Invitation to Tender (ITT)

Laboratory Centre for Disease Control (LCDC) Fire Alarm Replacement Project- 100 Eglantine Driveway

ANNEX I QUESTIONS AND ANSWERS

**GENERAL NOTES & EXISTING
DEVICE COUNTS**

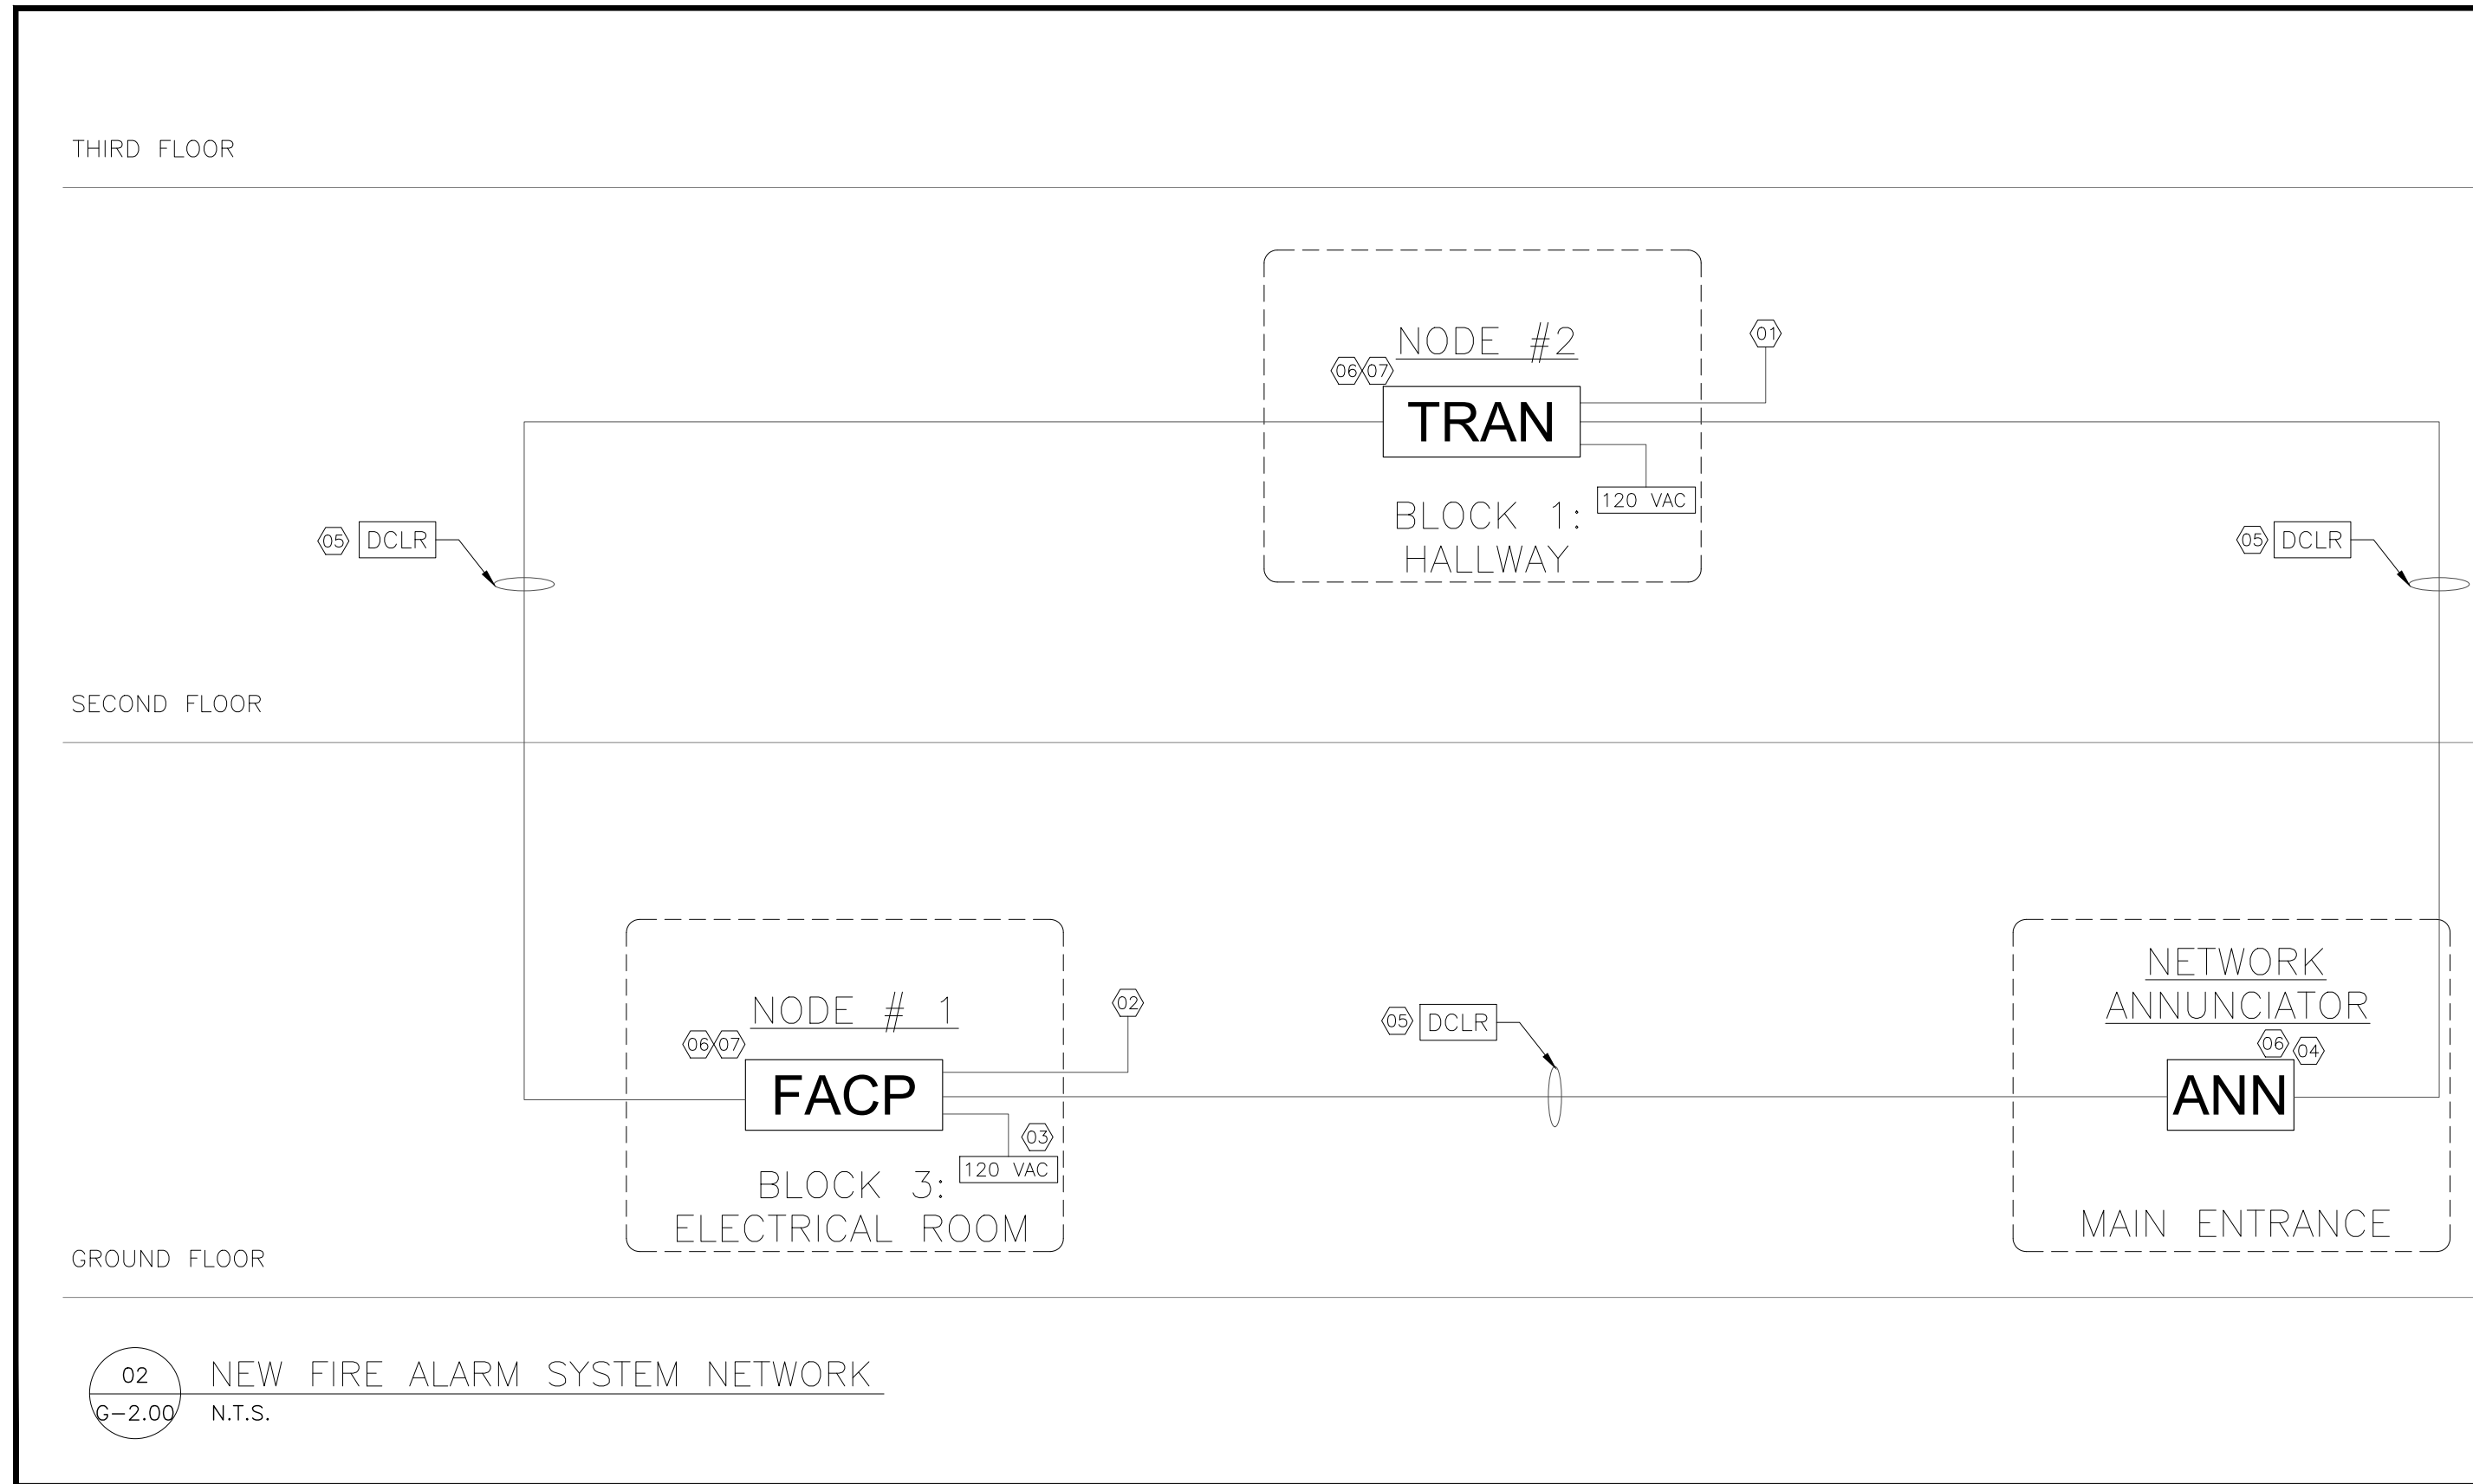
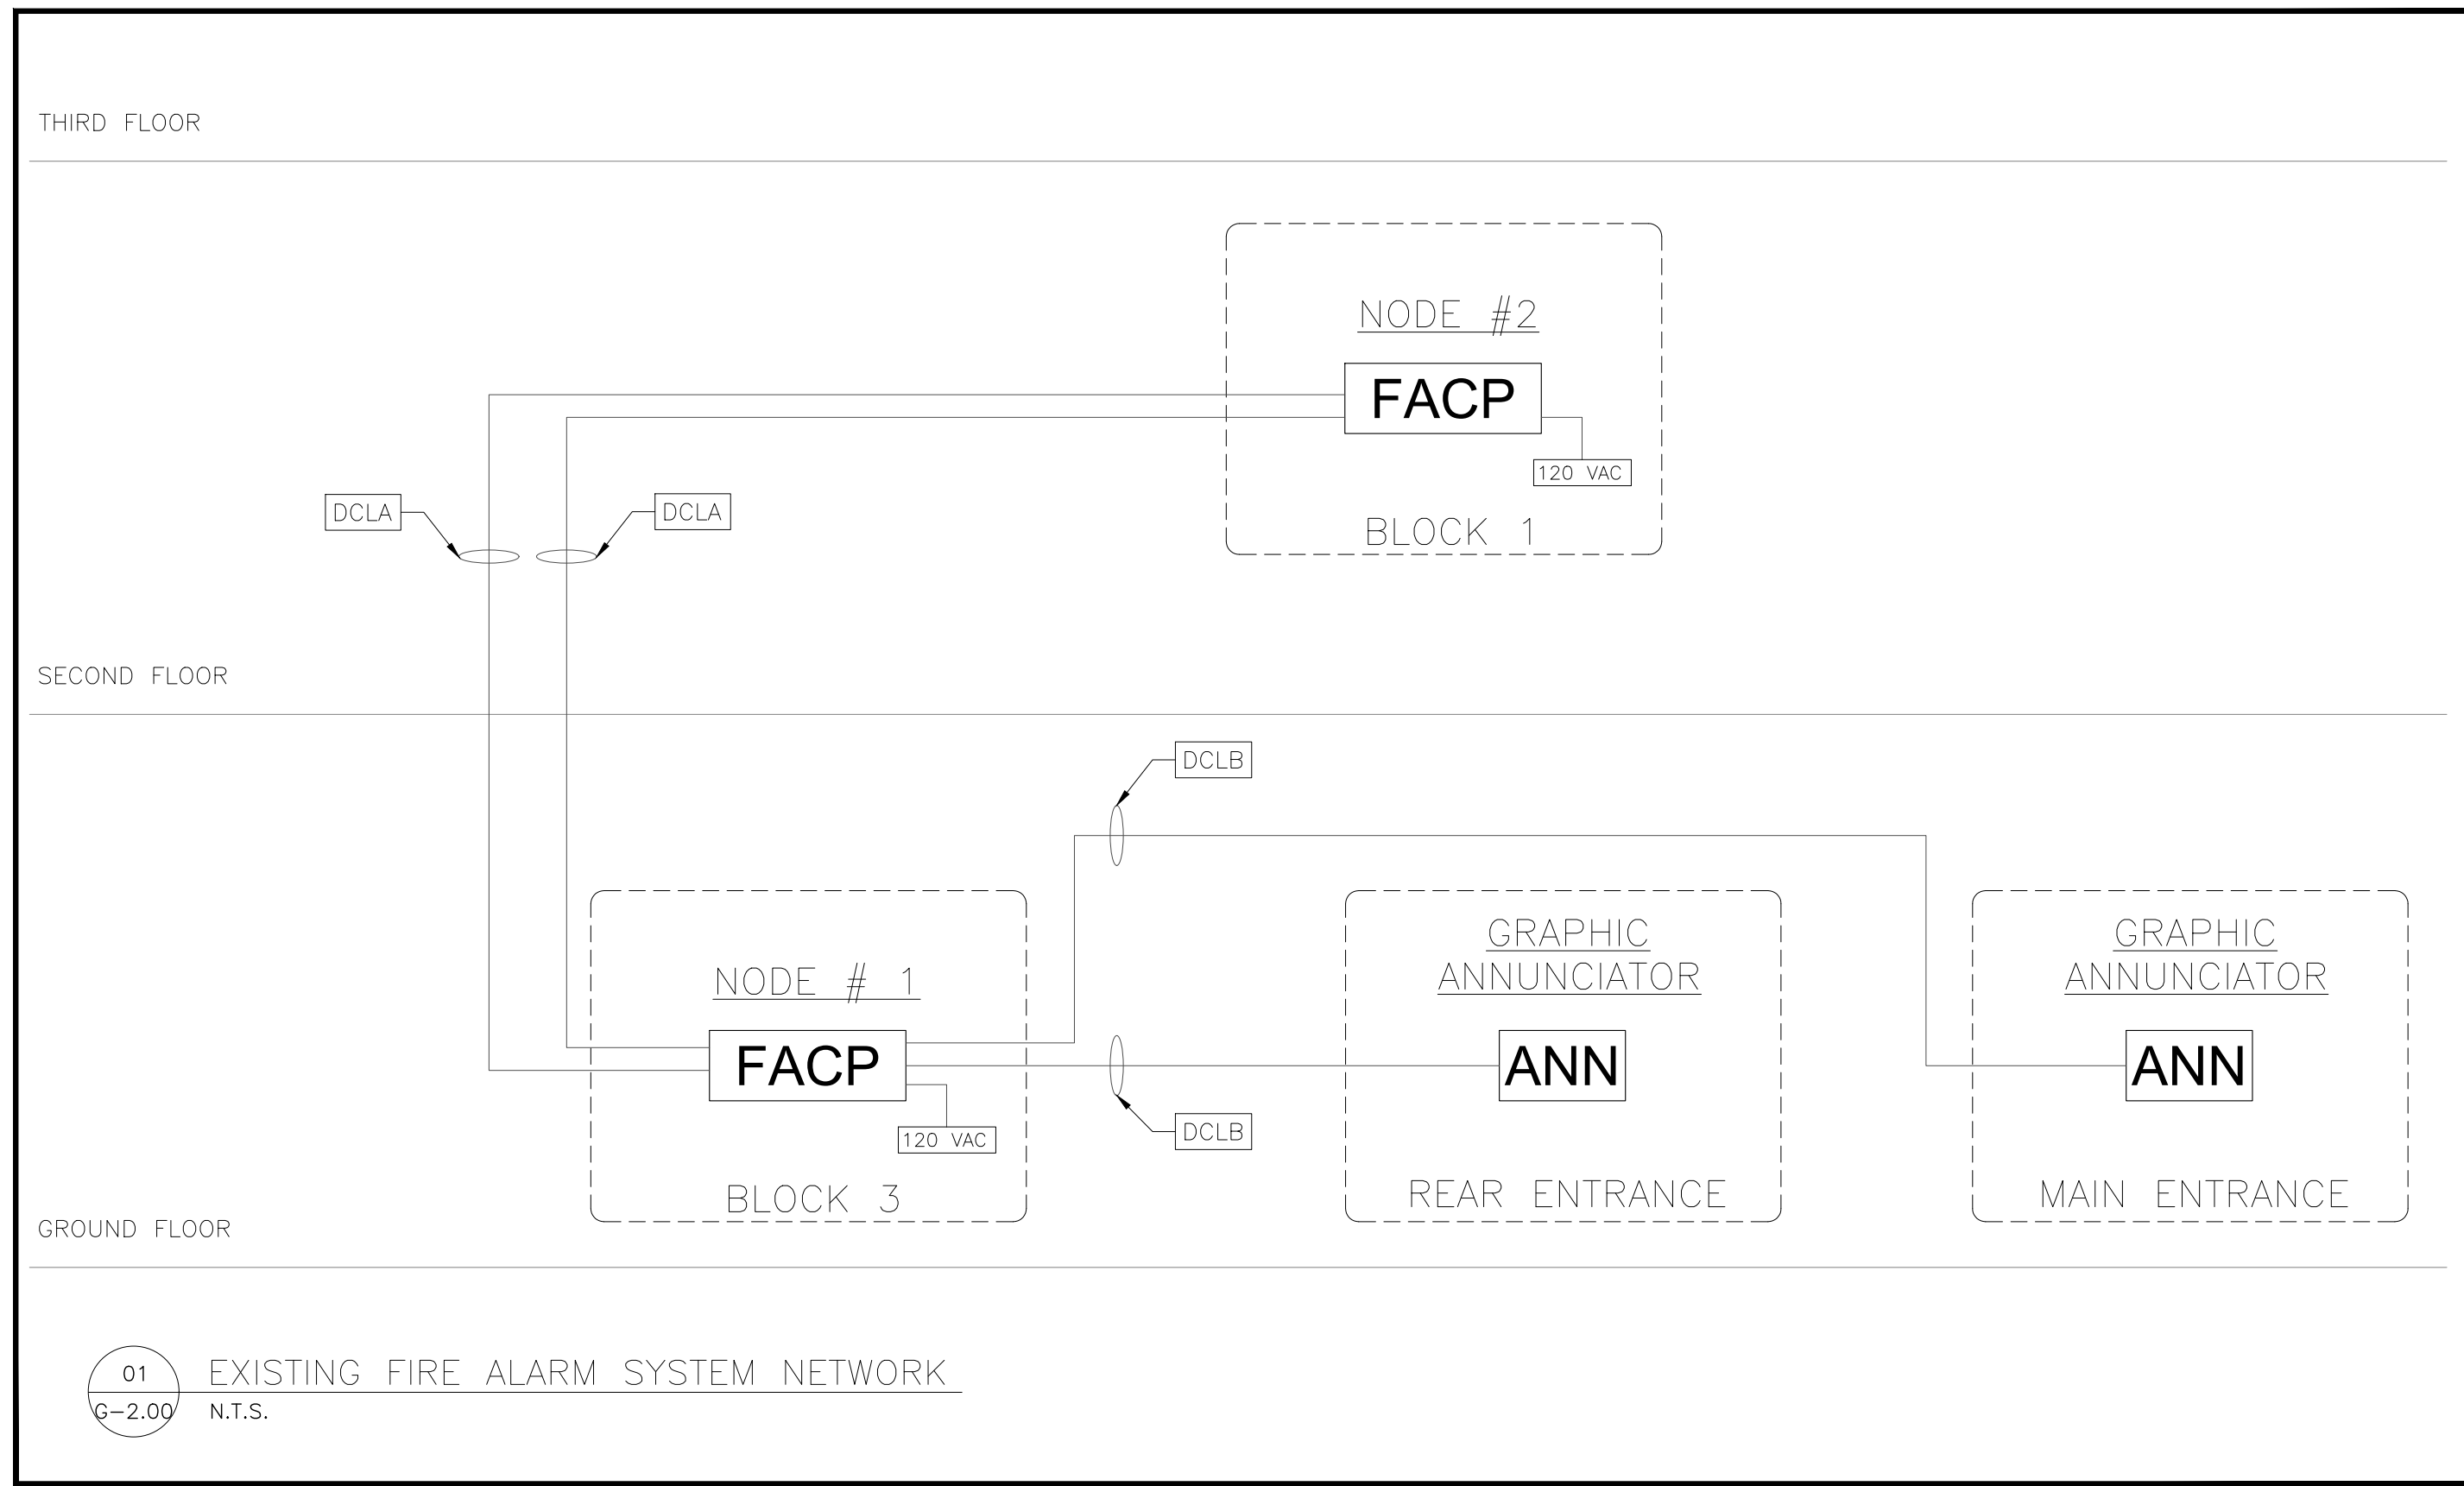
On drawing G1.0 existing device counts, are we replacing all of these & adding all the new fire alarm pull stations & smoke detectors? Please confirm.

From drawing G1.0. All detection and control devices are being replaced and all signalling devices are being retained. Please refer to Items 1.10 to 1.17.
